SUBJECT: ISSUANCE OF AMENDMENT NOS. 172 AND 51 TO FACILITY OPERATING LICENSES
DPR-66 AND NPF-73, IN RESPONSE TO CHANGE REQUEST NOS. 208/74,
REDUCED THERMAL DESIGN FLOW (TAC NOS. M85819 AND M85820)

SUBJECT: ISSUANCE OF AMENDMENT NOS. 172 AND 51 TO FACILITY OPERATING LICENSES
DPR-66 AND NPF-73, IN RESPONSE TO CHANGE REQUEST NOS. 208/74,
REDUCED THERMAL DESIGN FLOW (TAC NOS. M85819 AND M85820)

SAFETY EVALUATION BY THE OFFICE OF NUCLEAR REACTOR REGULATION
RELATED TO AMENDMENT NO. 172 TO FACILITY OPERATING LICENSE NO. DPR-66
AMENDMENT NO. 51 TO FACILITY OPERATING LICENSE NO. NPF-73

BEAVER VALLEY POWER STATION, UNIT NOS. 1 AND 2

FIGURE 2.1-1

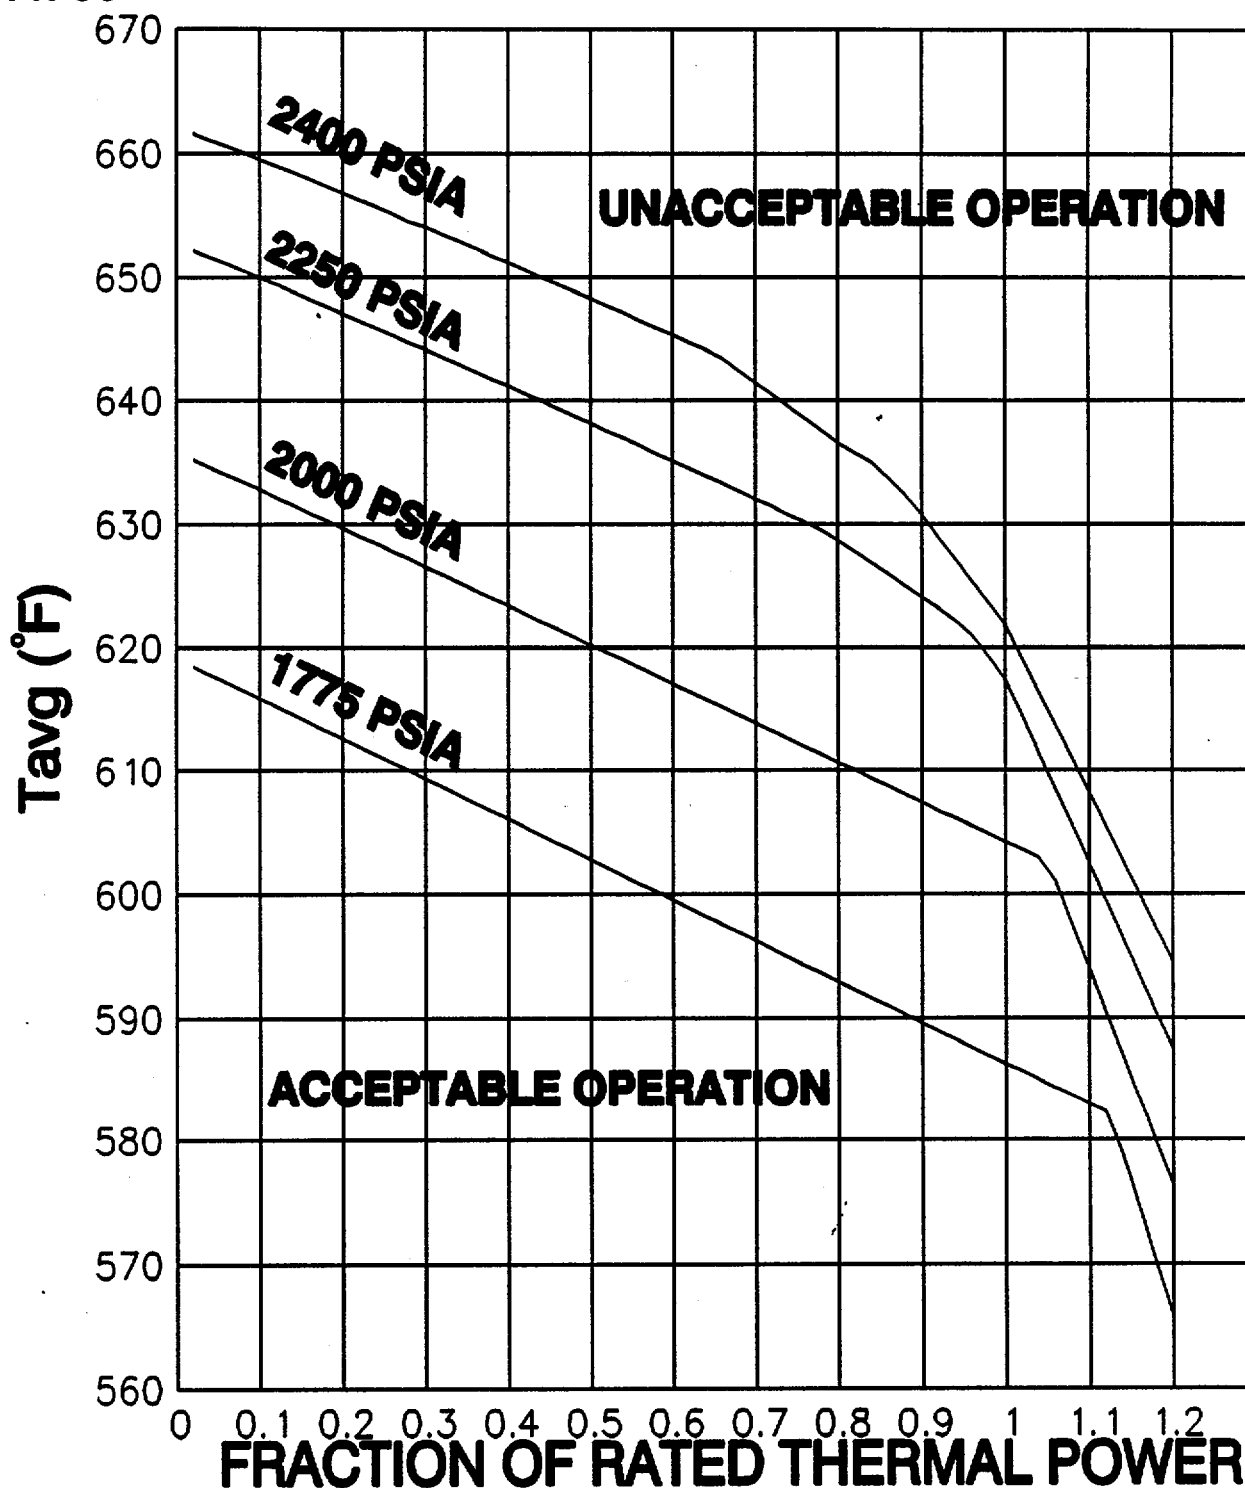
To support the proposed reduction in flow, the exit boiling portion of the core thermal limits illustrated in Figure 2.1-1 required revision for Units 1 and 2. Additionally, Figures 2.1-2 and 2.1-3 (and all references to them) have been deleted for Unit 1. These figures, which provide core thermal limits for two-loop operation, are extraneous because plant operation with less than three loops is not permitted under the current license. Similarly, the limits pertaining to two-loop operation in Table 3.2-1 for Unit 1 have been deleted. The Unit 2 TS do not address two-loop operation.

With regard to the impact of the proposed flow reduction on core thermal limits, the licensee's evaluation indicates that the DNBR-limited segment of each thermal limit line in the current TS remains bounding. As noted above, the retained DNBR margin is large enough to accommodate the penalty assessed against it due to flow reduction. The vessel exit boiling segment of each thermal limit line was revised, however, to reflect the 1.5 percent reduction in flow. The effect is less than a 1°F decrease in exit boiling limits. Additionally, the licensee confirmed that the current OT delta-T and OP delta-T setpoint equations continue to provide protection for the revised core thermal limits.
